Addendum

DATE: 12/22/2023

PROJECT: 614, 624 & 702 Building Renovation and
Addition
East End Community Services / West Care

ADDENDUM NO. 1

TITLE
LANDSCAPE PLAN

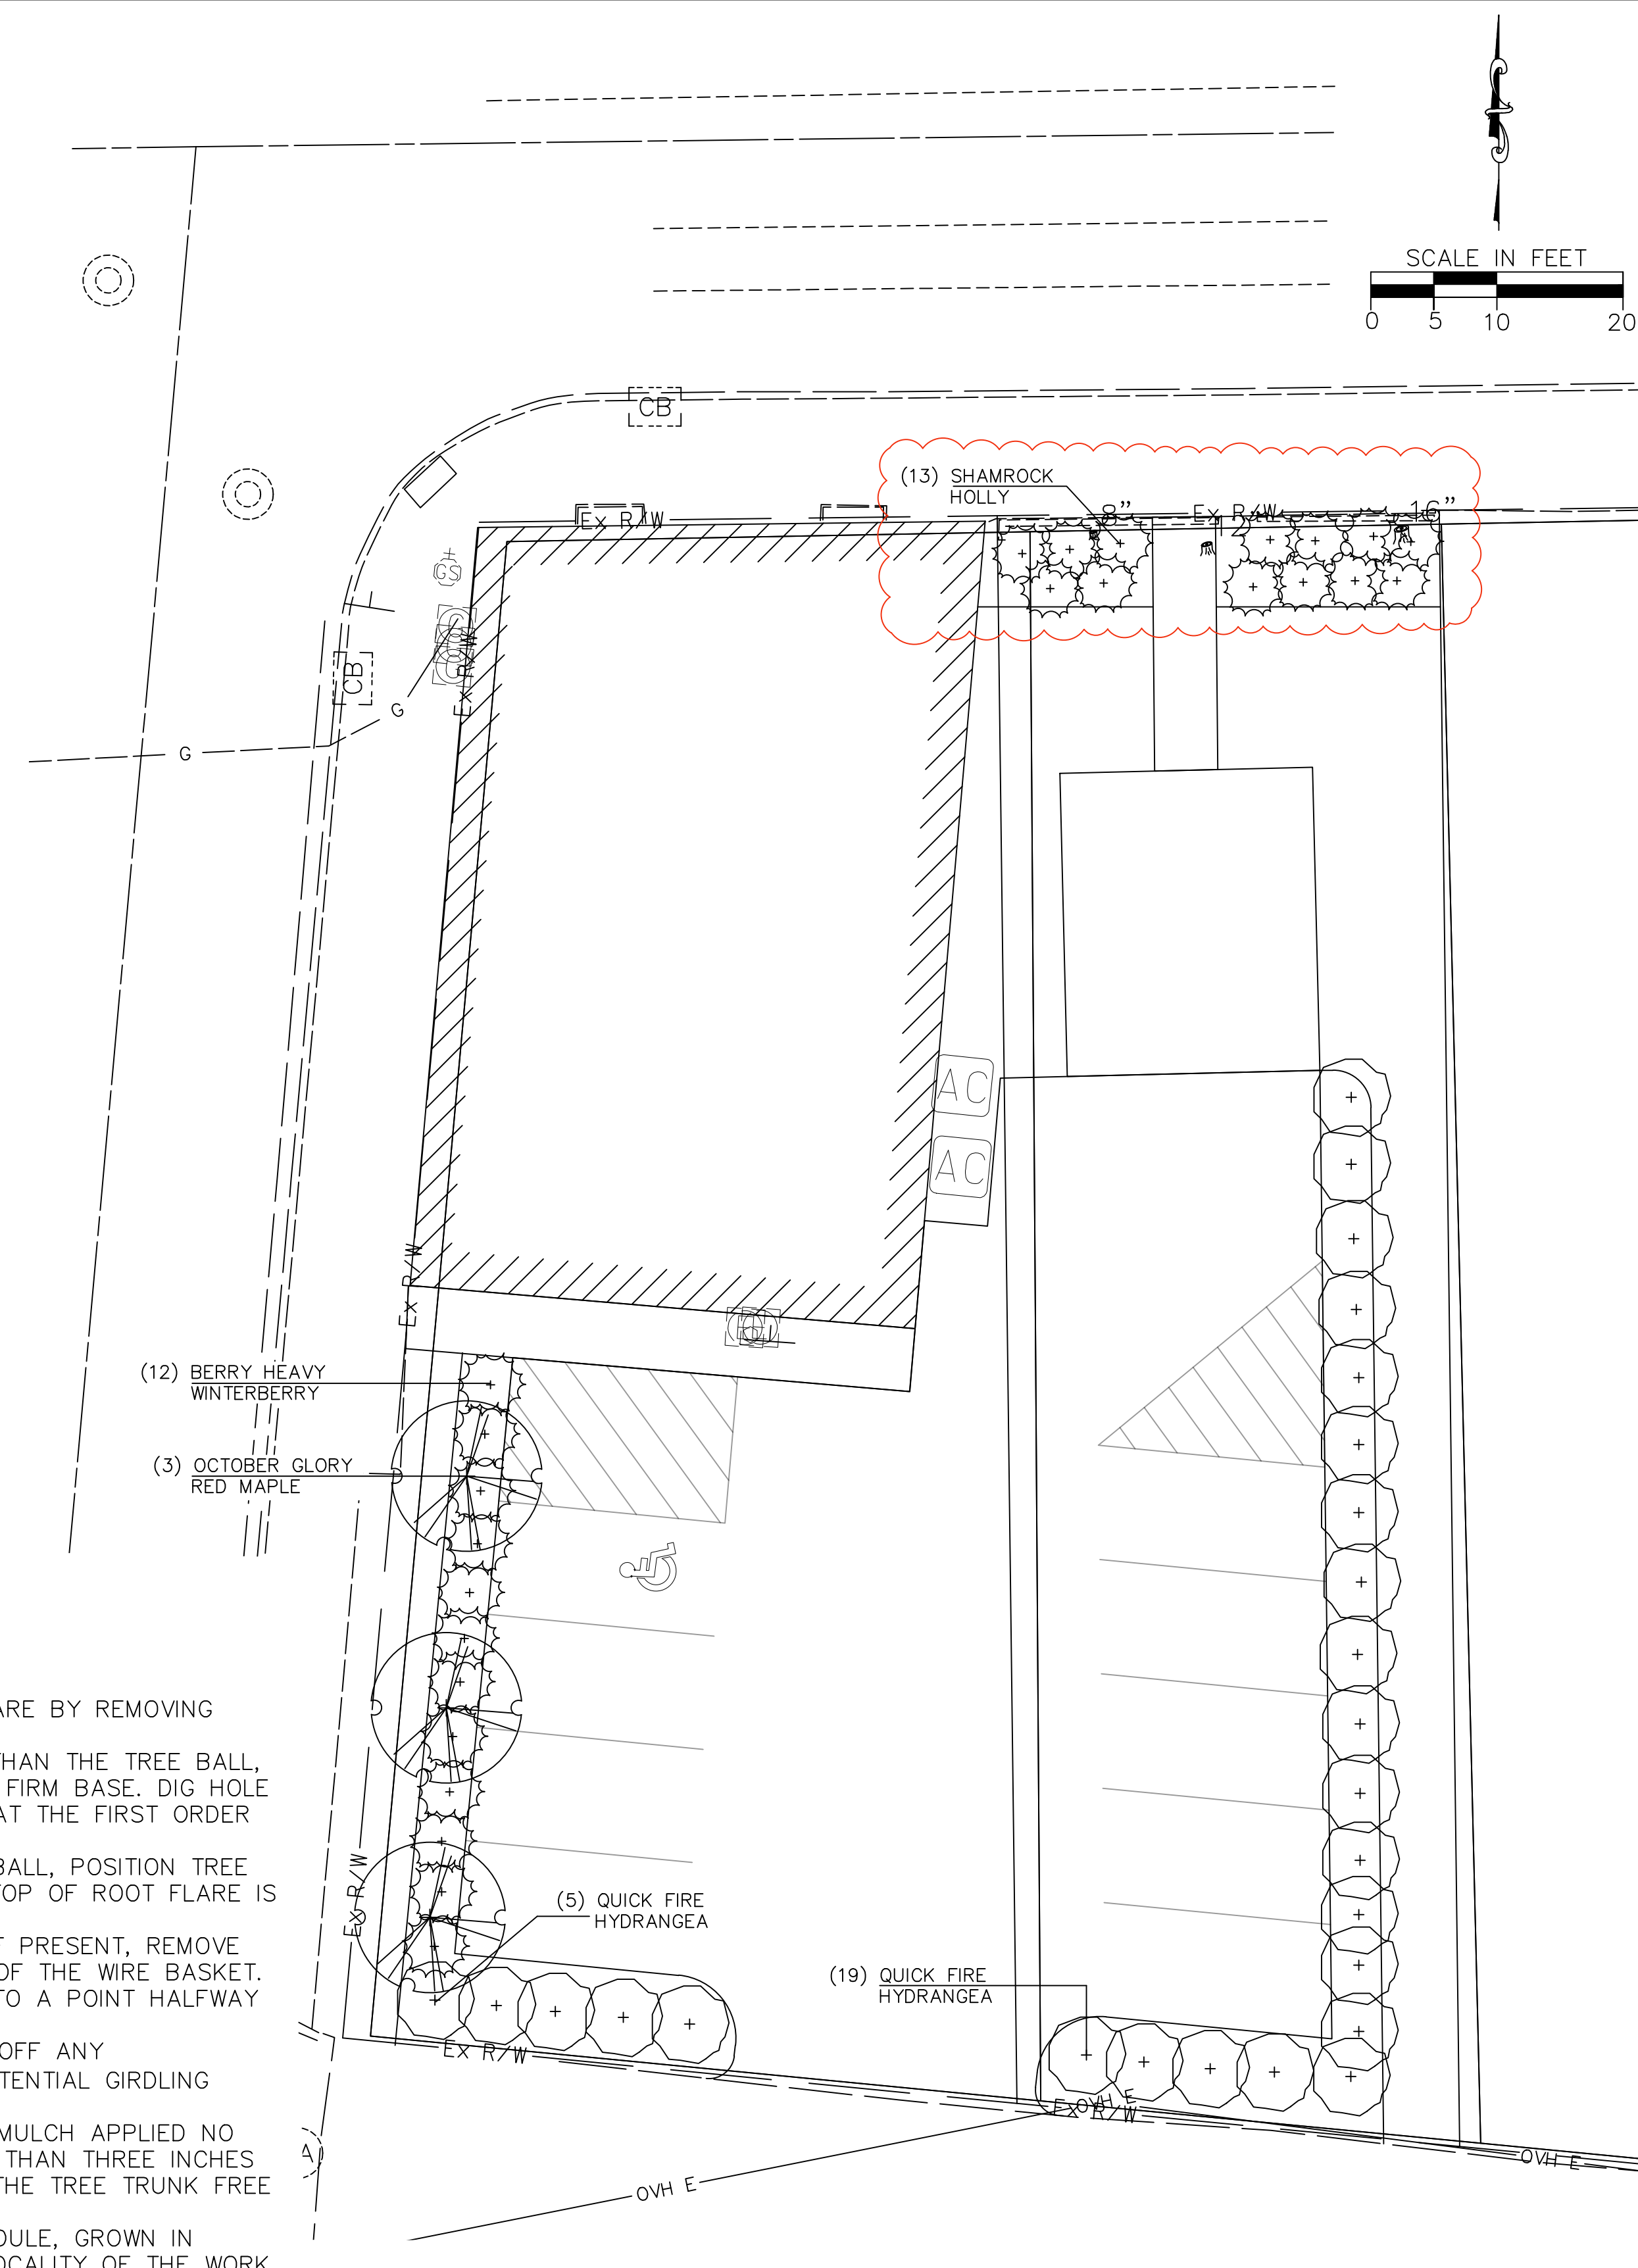
ITEM C2 SHEET C3.1 – LANDSCAPE PLAN (702 Garage)
1. Revisions to landscape plantings
